## **Wainui Beach Management Strategy - Review**

In June 2010, Tonkin & Taylor Ltd were commissioned to carry out an independent review of the "Wainui Beach Management Strategy" (W.B.M.S). Our review has been based on a desktop review of existing reports, meetings and a site visit to the beach on 8 July 2010. At the same time Gisborne District Council (GDC) had submitted a consent application for construction of the WBMS Section 3 works. The hearing for this consent was held in mid June and consent was declined in July. This report includes our review of the WBMS and also comments on the result of the consent hearing and the Commissioners' Hearing Report.

<b>GISBORNE DISTRICT COUNCIL</b>	<b>CONCRETE GROUYNE 28 TO WAINUI STREAM          PROPOSED SLOPING ROCK REVETMENT          TYPICAL SECTION</b>				SCALE : 1:50	TRACED	PLAN NUMBER
	DESIGNED	R.BUDD	10/09				<b>EW300-2</b>
	DRAWN	D.HEMM	10/09

**Appendix A:            Gisborne District Council Drawing EW244/1**

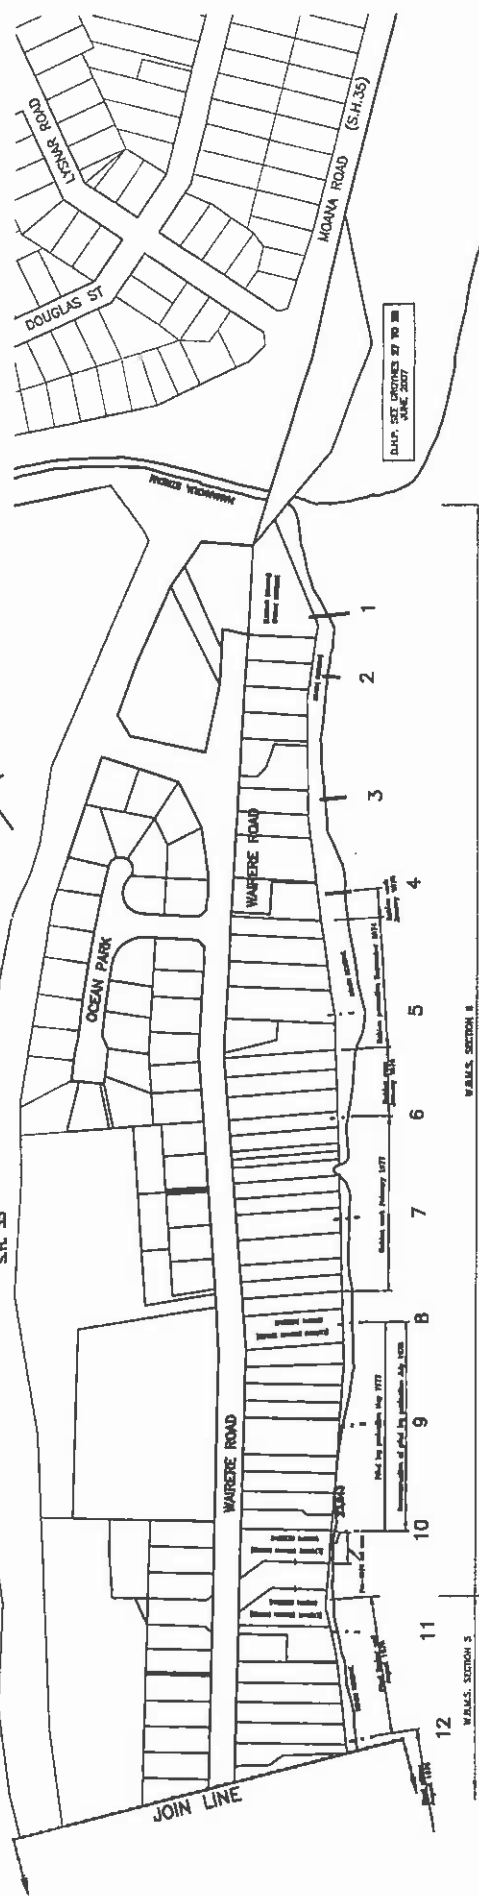
Section 1 extends from Tuahine Point in the south to approximately the position of the old steel groyne no. 28 (as shown on Gisborne District Council Drawing EW244/1, see Appendix A).

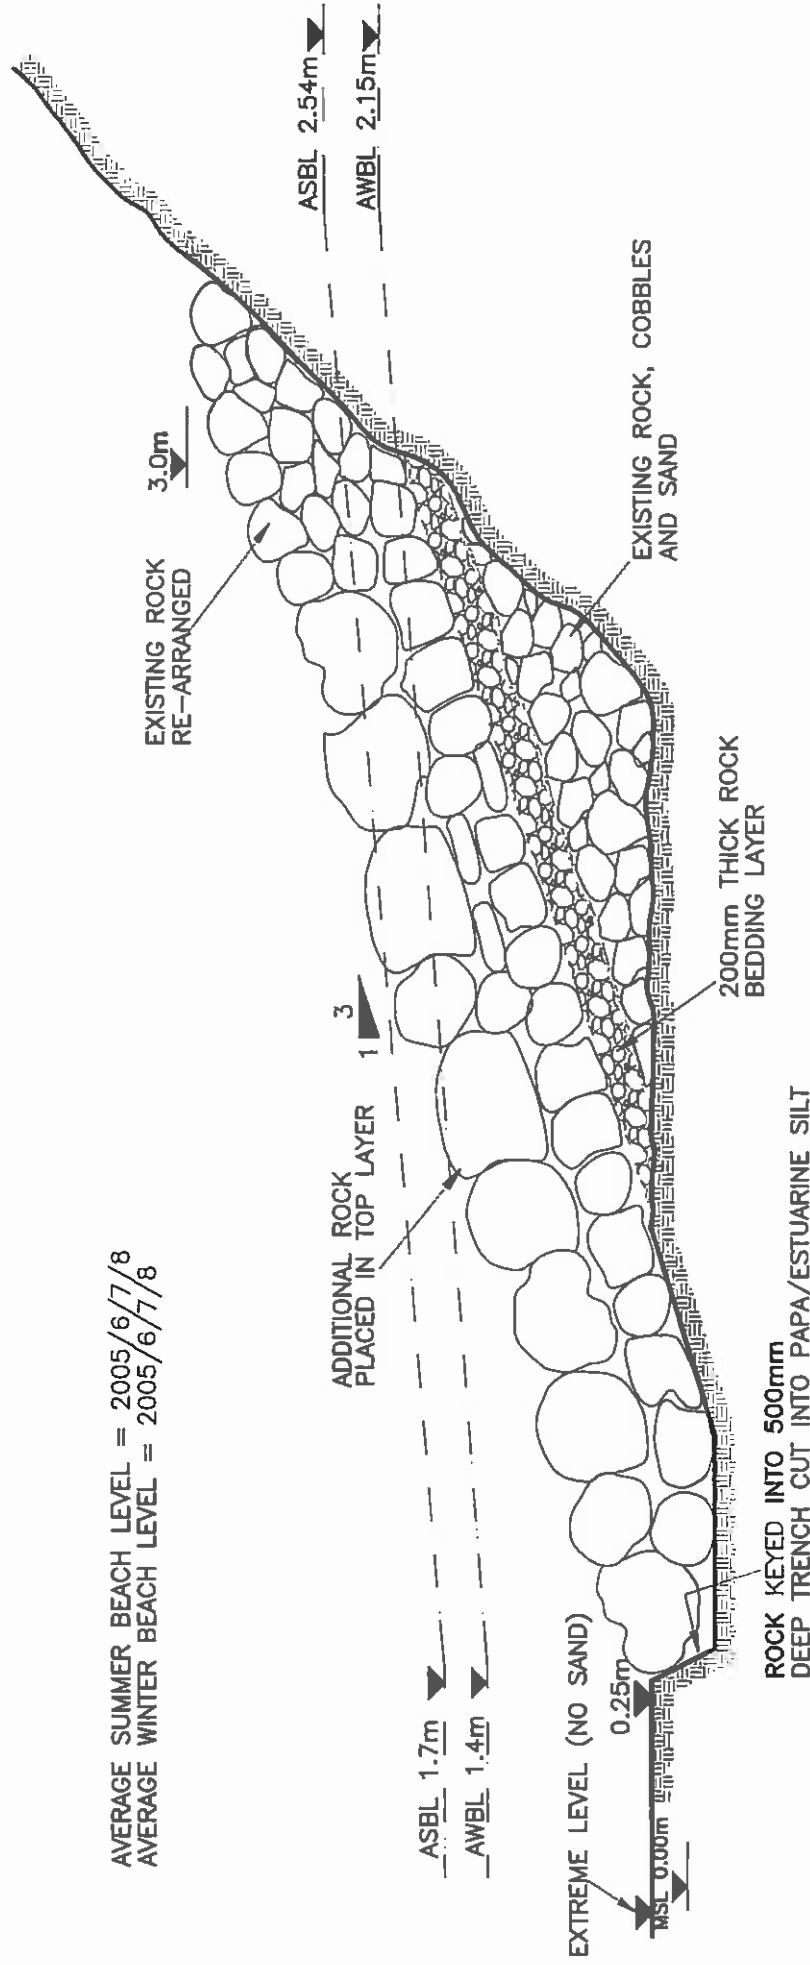
The proposed sloping rock revetment, which was included in the recent Resource Consent, is shown in Appendix C. It generally involves large rock armour on a layer of smaller rock on a layer of fill

including beach cobbles and sand. The revetment has a slope of 1 vertical to 3 horizontal, and its toe is embedded 0.5 m into a trench excavated into the underlying papa/estuarine silt layer. The toe is shown as being at an elevation of 0.25 m above Mean Sea Level (M.S.L.) and the crest at an elevation of 3.0 m above MSL.

- While rock armour size and layer thickness is not shown on the drawing, we note that a conventional rock armour layer involves a two-stone thick layer with surface layer stones the same size and the lower layer of stones in the same armour construction. The drawing depicts a single layer of larger armour on top of smaller stones. This construction has less permeability than ideal and absorbs less energy. It also has less interlock between stones which reduces the stability of the surface armour stones.

- The drawing shows the crest of the armour layer being formed with smaller stones than the main armour stones. Crest stones should in fact be the same size as the main armour, particularly where severe wave action can overtop the crest as smaller stones can be readily plucked from the crest and removed by wave action.

- We support the toe of the armour being constructed in a trench cut into the underlying papa. The depth of this trench should be approximately equivalent to the average size of an armour stone. As the size of the armour stones is not shown on the drawing we are not able to comment as to whether the 500 mm depth proposed is adequate. The aim should be to construct a relatively smooth transition between exposed papa shelf in front of the revetment and the general line of the rock armour.

- The depth of toe excavation may need to be greater in the estuarine silt material to allow for some future down-cutting of this material in front of the wall. In areas away from the papa formation, the extent of toe embedment should be considered in relation to the lowest recorded level of the beach profile at those locations, with the rock armour extending approximately 1.0 m below the lowest recorded beach elevation.

- Material excavated from the toe is often used as fill beneath the armour and secondary rock layers (underlayers), to form the correct slope of the revetment. Beach cobbles should ideally be left on the beach as these help to armour the beach in front of the revetment when beach levels are low, see Photo 3, and will reduce further down-cutting of the beach. This has also been identified by Komar, and we support maximising the use of natural beach cobbles in front of the revetment.

- Fine-grained fill material (e.g. sand or silt material), needs to be contained and prevented from washing out through the revetment causing cavities and slumping of the revetment. This is usually achieved with a suitable geotextile layer placed between the fill and the rock underlayer. This geotextile should also extend into and cover the base of the toe excavation, and should extend up the cliff or embankment to armour crest level. No geotextile is shown on the current Council cross-section.

- Armour slope has been set at 1 vertical to 3 horizontal. Flatter armour slopes generally reduce wave run-up levels, as do more porous armour textures. If the armour layer is redesigned as a two-stone thick layer of equivalent stone size throughout, this will have greater porosity than the design shown on the Drawing. This would then allow the armour slope to be steepened to

be 1 vertical to 2 horizontal, or even 1 vertical to 1.5 horizontal thus minimising the footprint of beach utilised by the revetment. The area occupied by the revetment was a significant issue in the Resource Consent Hearing.
